SB 70-226

SUBJECT : GAS CONTROLLER UPGRADE

REFERENCE : MODIFICATION SHEET No. MOD70-0454-21

EFFECTIVITY : TBM 700 aircraft S/N 434 to 1097

Figure 1 – S/N 434 to 684 – A300 Calculator wiring modification

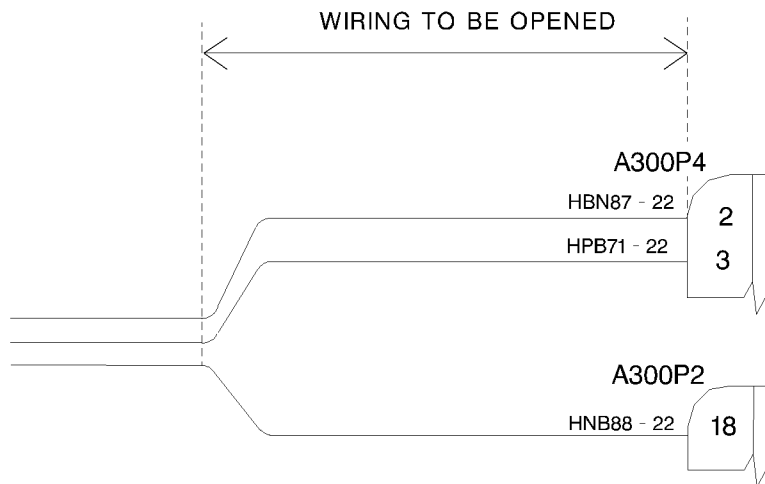
- 2) Open A300–P4 connector.
- 3) From the wiring harness, retain the wire(s) removed from the connector, then remove heat-shrinkable sleeve used to isolate the contact.
- 4) Using insertion/extraction tool, remove and relocate as follows :
 - HPB71–22 into stud 2.
- 5) Close A300–P4 connector.

Figure 2 – S/N 687 to 1097 – A300 Calculator wiring modification

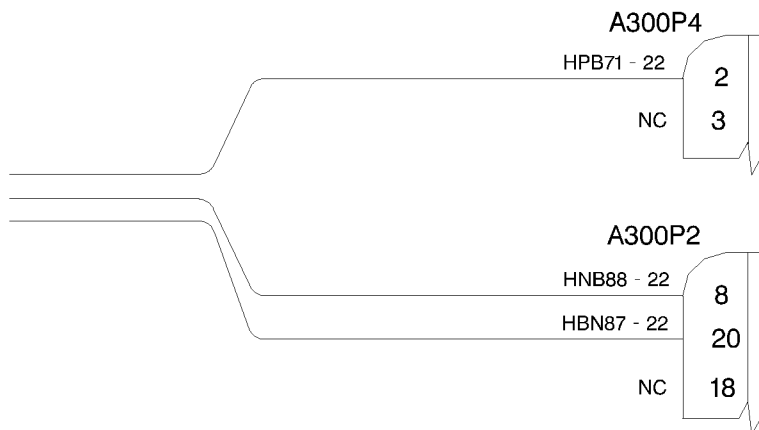
- 2) Open A300–P2 and P4 connectors.
- 3) In accordance with Figure 2, cut the sheath and open A300–P2 and P4 wirings.
- 4) From the wiring harness, retain the wire(s) removed from the connector, then remove heat-shrinkable sleeve used to isolate the contact.

- HPB71-22 into stud 2,
- HNB88-22 into stud 8,
- HBN87-22 into stud 20.
